U.S. Application No. 09/933,198

Docket No. 1190-0508P

AMENDMENTS TO THE DRAWINGS

FIG. 8

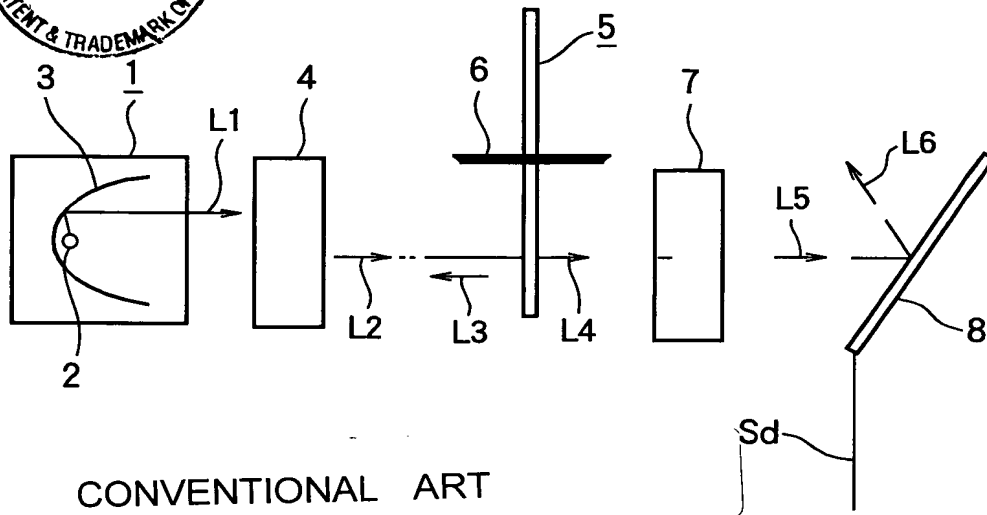
Attached hereto are three (3) annotated sheets of proposed drawing corrections for Figures 8-13, and corresponding three (3) formal drawing sheets. Figures 8-13 have all been amended to include the legend "Conventional Art" to address the objection raised in the Office Action.

CONVENTIONAL ART
